THE ILLINOIS STATE TOLL HIGHWAY AUTHORITY

DESIGN BULLETIN No. 20-04

SUBJECT: VWIM Base Sheets Updates

WEIGH-IN-MOTION CABINET AND FOUNDATION DETAILS

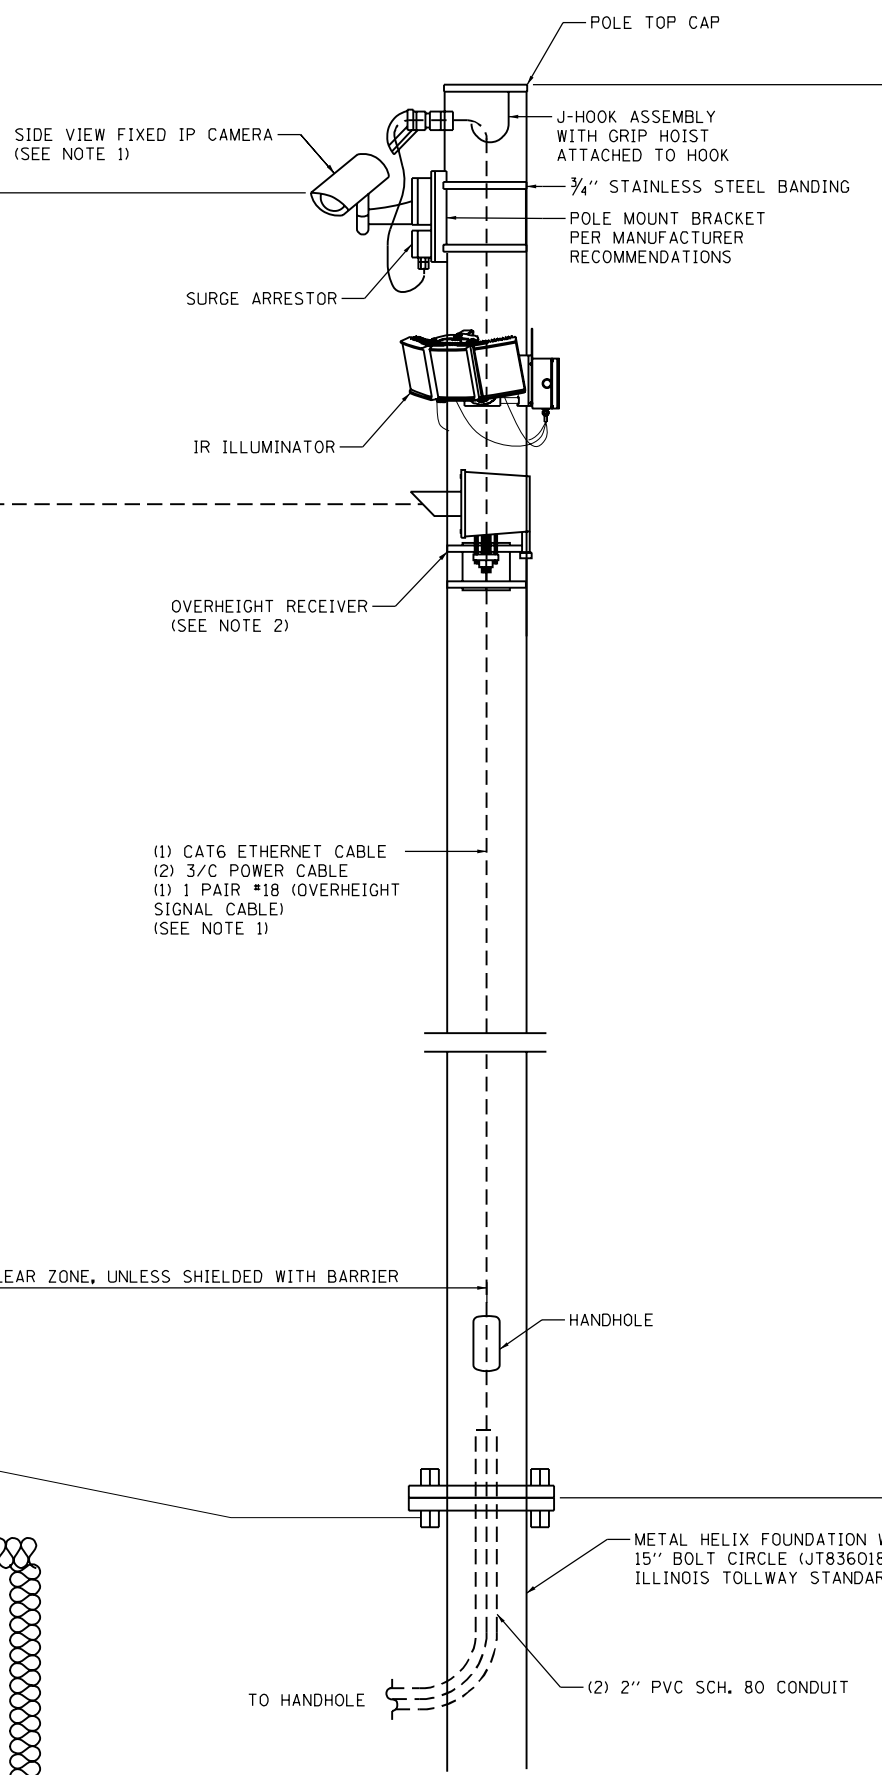
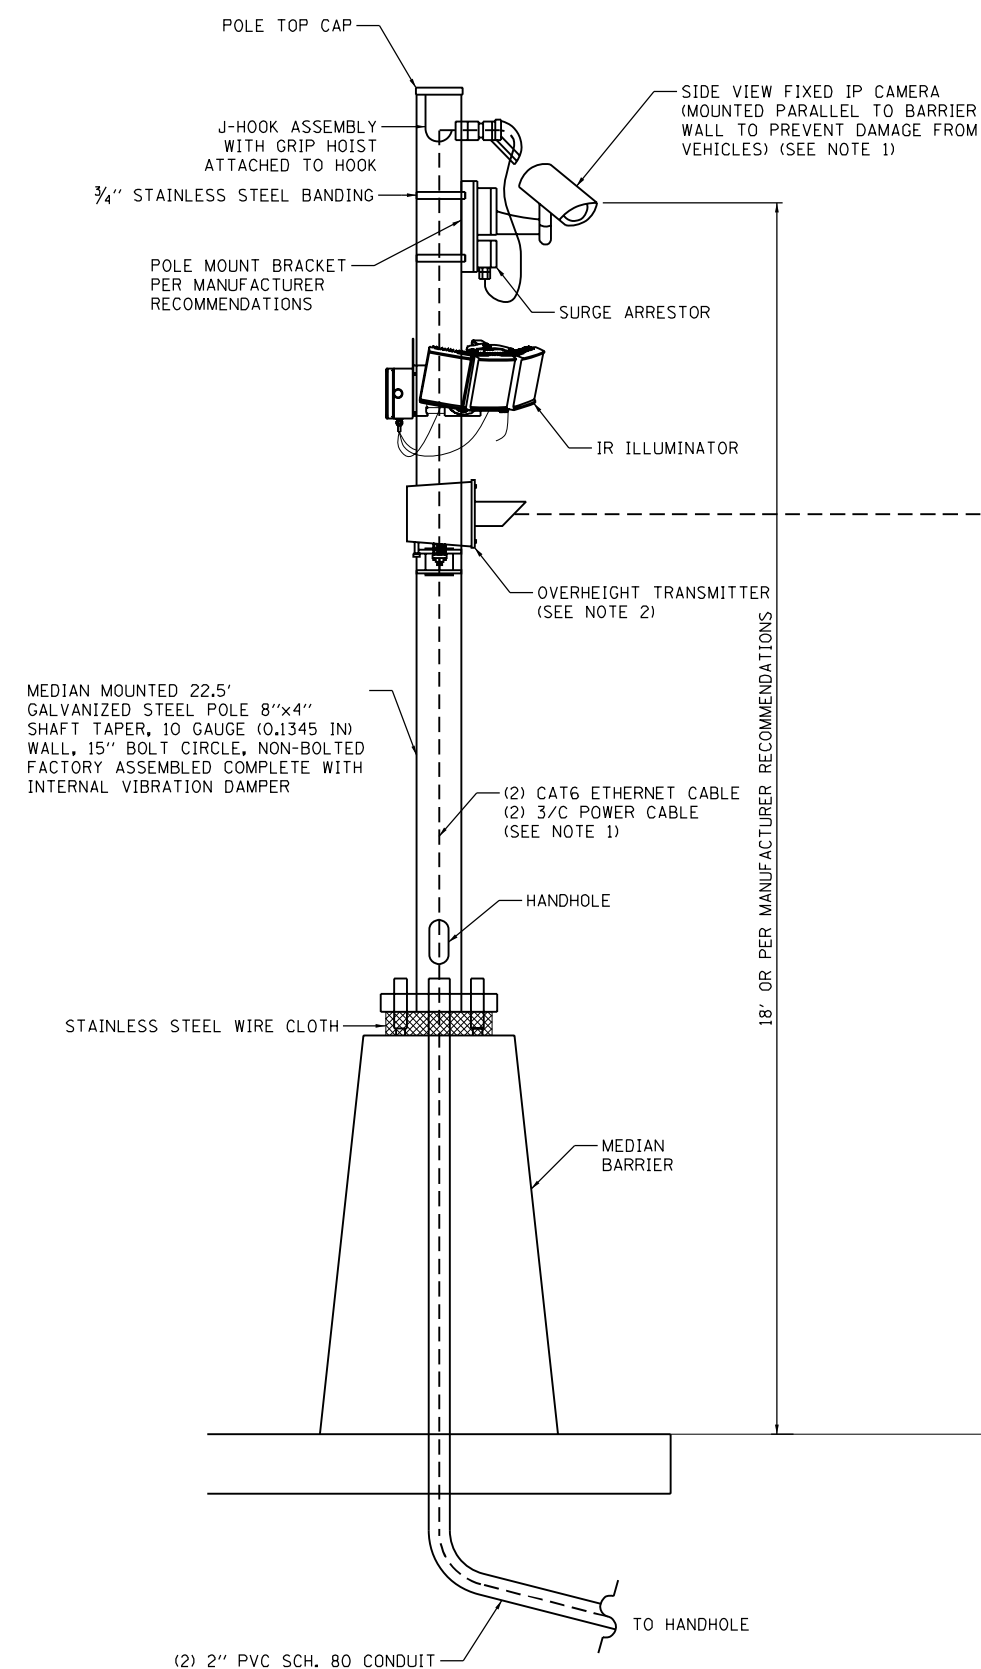
Section M Base Sheet Drawings	
Drawing	Modification Summary
	Effective: 2020-08-28
Weigh-in-Motion (ITS)-Series 1600	
M-ITS-1600	Weigh-In-Motion Cabinet and Foundation Details
	Revised the cabinet foundation heights, added detail of front door and revised foundation note 1.
M-ITS-1601	Weigh-In-Motion IP Camera Details
	Revised details to show all devices on the IP camera poles, use 22.5' median pole, revised conduits and cabling, and clarified setback requirements.
M-ITS-1602	Weigh-In-Motion Loop Detector Details
	Added loop cable routing details, added preformed loop details, removed detector housings, and revised notes.
M-ITS-1603	Weigh-In-Motion Site Layout 3 Lanes (3 sheets)
	Complete revision to this sheet. Previous sheet was for 4 lanes. Created 3 sheets for site overview, wiring layout and site layout.
M-ITS-1604	Weigh-In-Motion Site Layout 4 Lanes (3 sheets)
	Complete revision to this sheet. Previous sheet was for detector housing. Created 3 sheets for site overview, wiring layout and site layout.

**WEIGH-IN-MOTION
 SITE OVERVIEW
 3 LANES**

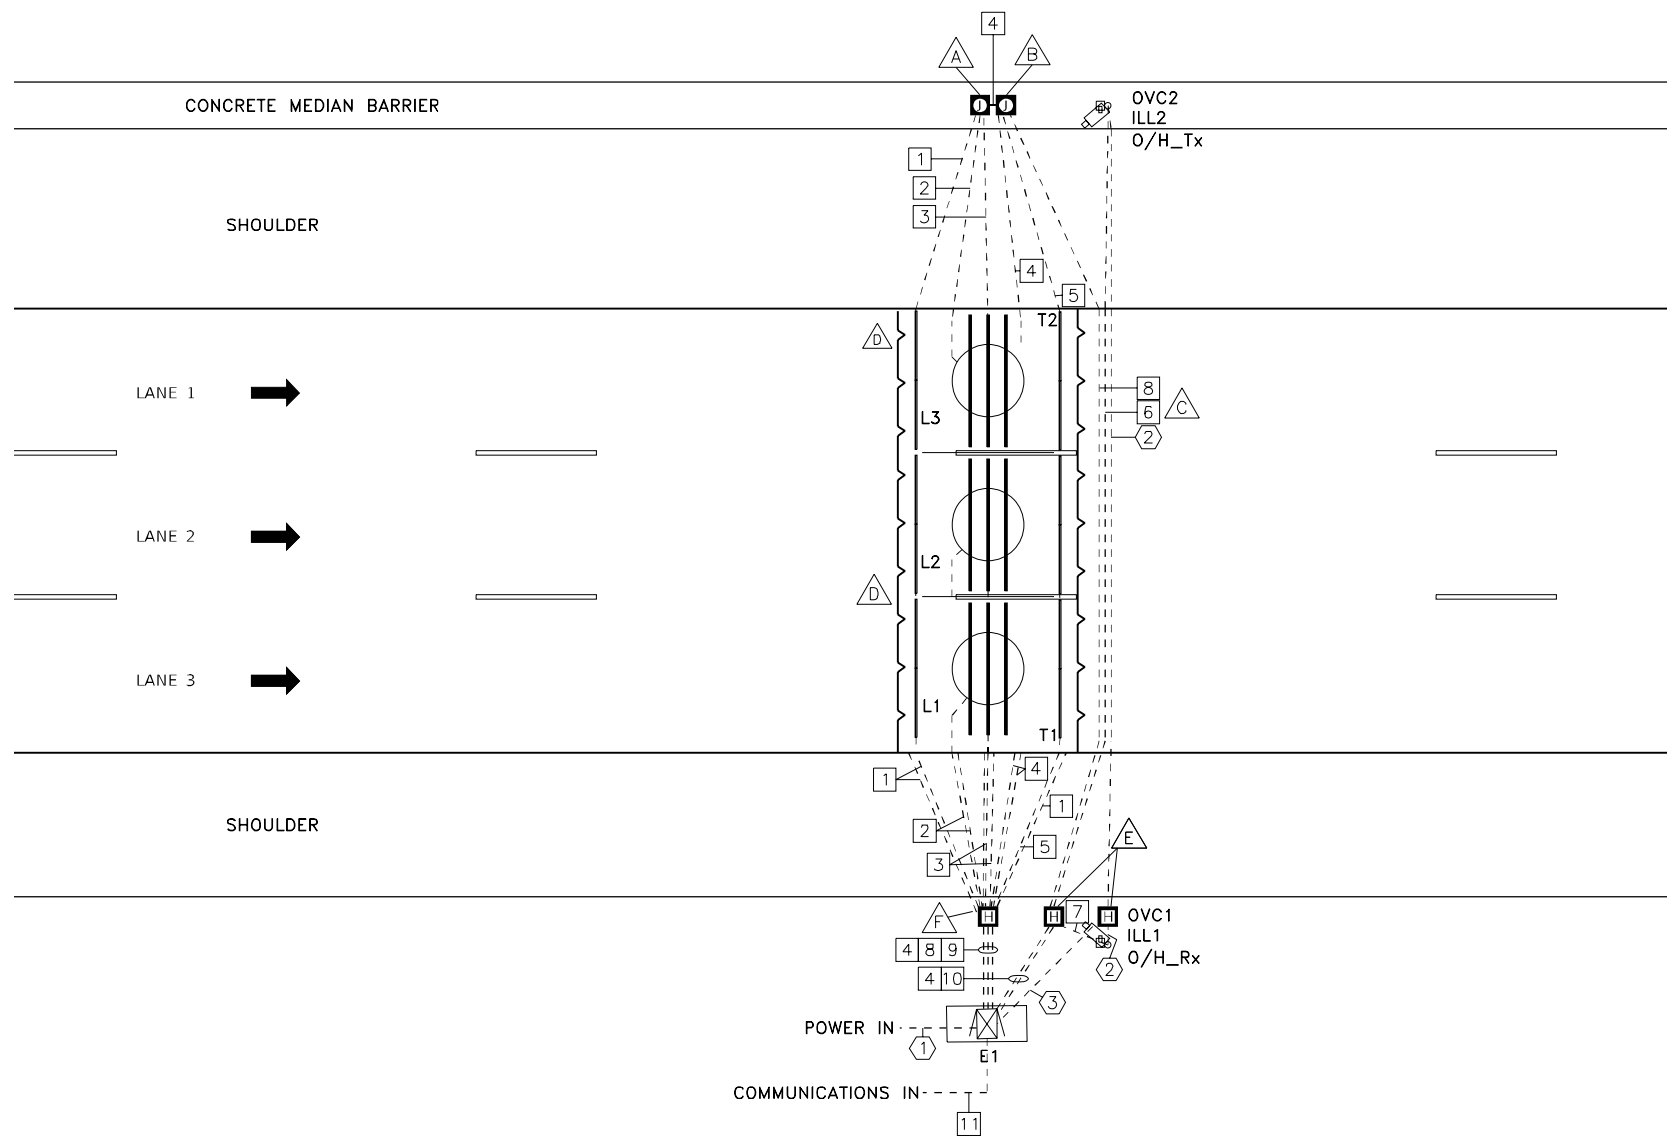
- Revised the layout for 3, 4 and 6 lanes and created (3) sheets for each lane configuration to show the layout, conduit/wiring sizes and conduit locations.
- Revised the details for precast (replacement) or cast-in-place (new construction) installation.
- Tightened up the sensor/loop arrangement.
- Revised cabinet foundation detail.
- Combined the overheight detector onto the camera poles and added distance of poles to VWIM sensors.
- Added detail for preformed loops and eliminated detector housings in shoulder.
- Increased size of median junction boxes to accommodate Vectorsense electronics box.
- Revised to utilize JPC pavement in VWIM section (new construction) with no overlay to allow diamond grinding.
- Revised to allow asphalt or concrete shoulders.
- Added details for sensor installation.

**WEIGH-IN-MOTION
SITE OVERVIEW
6 LANES**

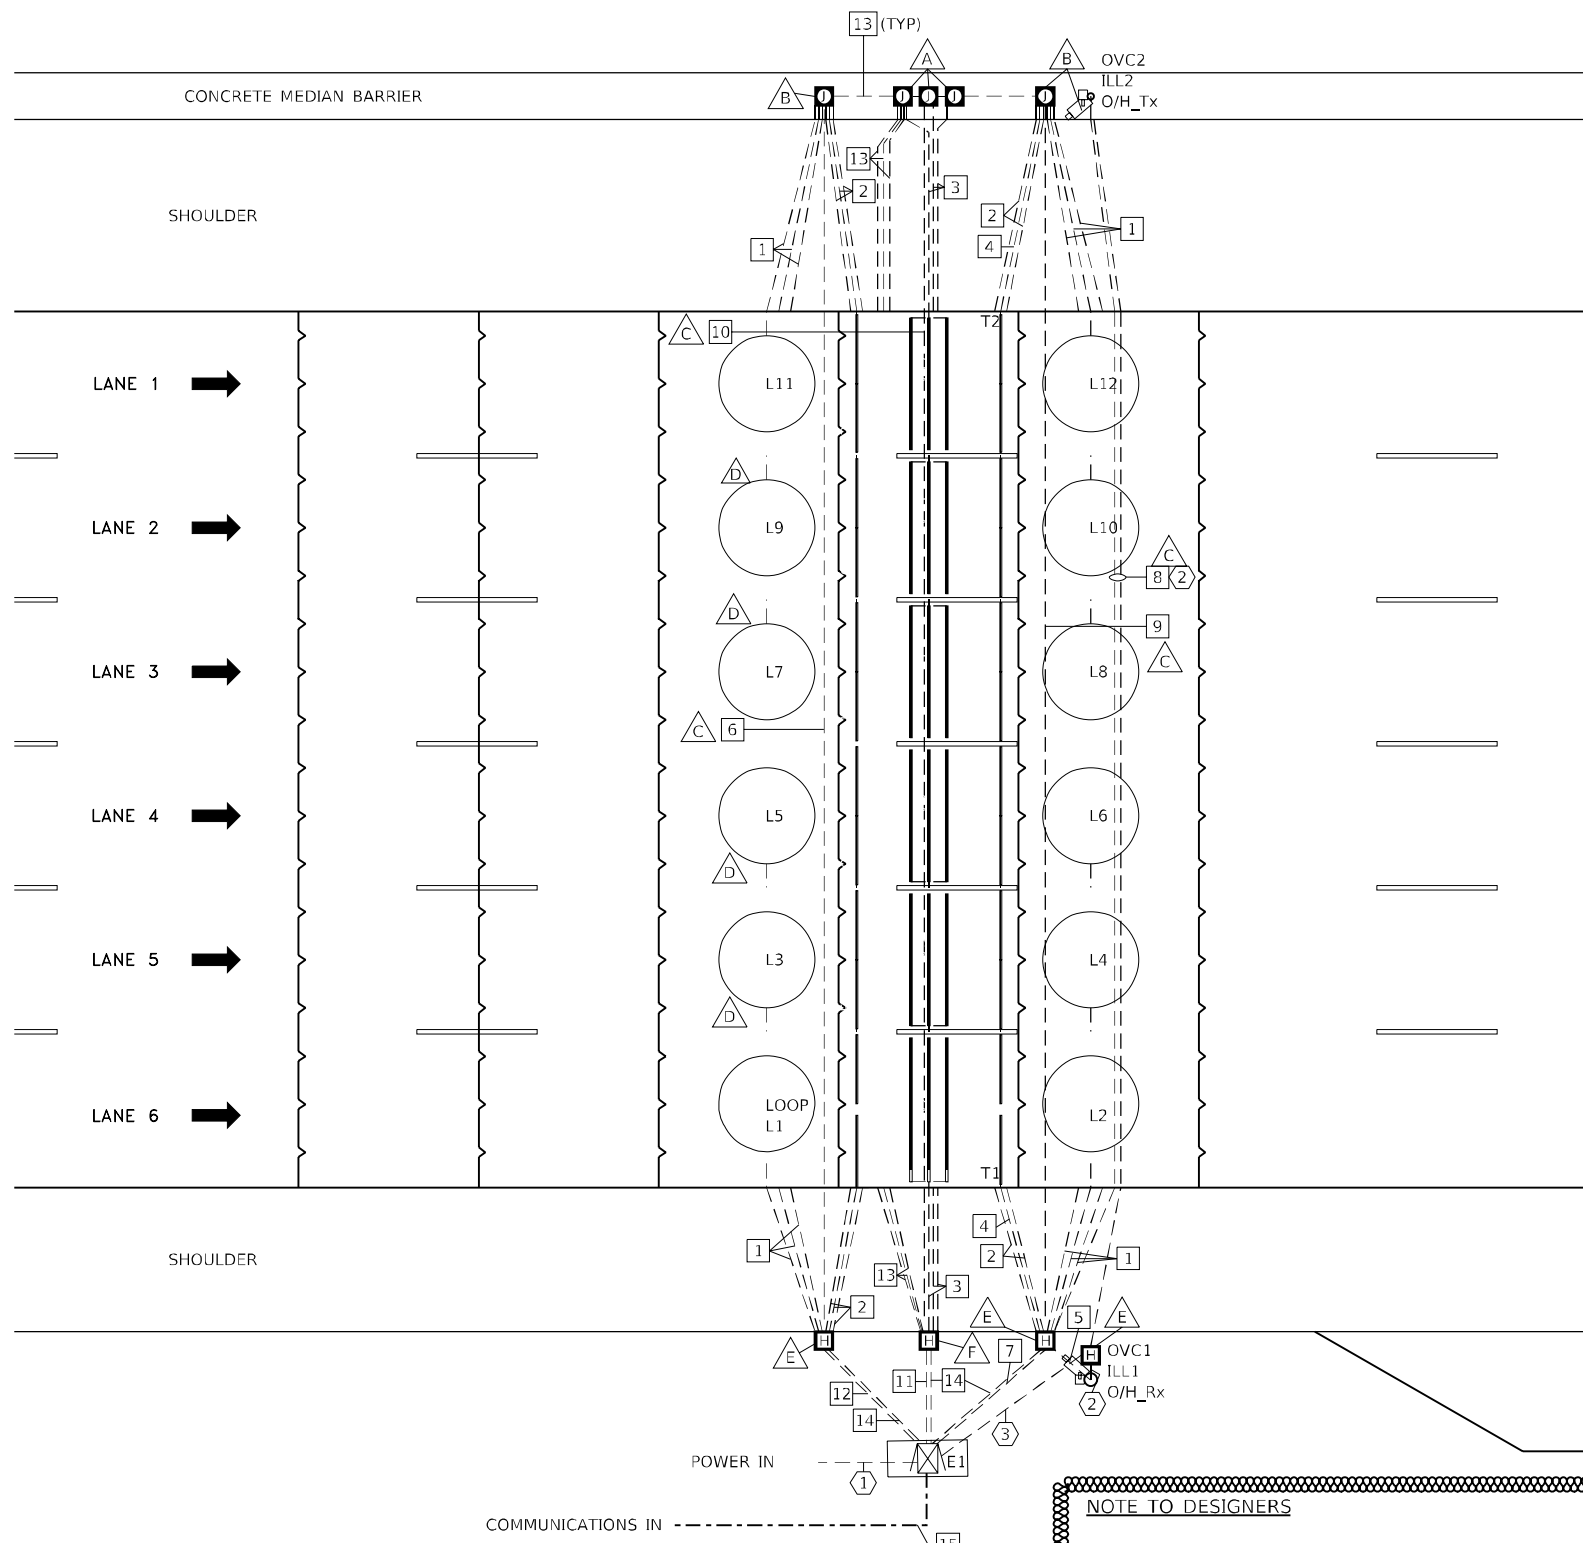
M-ITS-1605	Weigh-In-Motion Site Layout 6 Lanes (3 sheets)
	Complete revision to this sheet. Previous sheet was for detector housing. Created 3 sheets for site overview, wiring layout and site layout.
M-ITS-1606	Weigh-In-Motion Junction Box Detail
	Increased size of junction box to accommodate Vectorsense electronics box, revised conduits to match revised layouts and revised notes.
M-ITS-1607	Weigh-In-Motion Height Detector
	Added IP cameras and IR illuminators to poles, clarified pole types and detector height requirements, eliminated metric units, and revised conduit/handholes to match revised layouts.
M-ITS-1608	Weigh-In-Motion Quartz Sensor Details
	New sheet
M-ITS-1609	Weigh-In-Motion Vectorsense Sensor Details
	New sheet
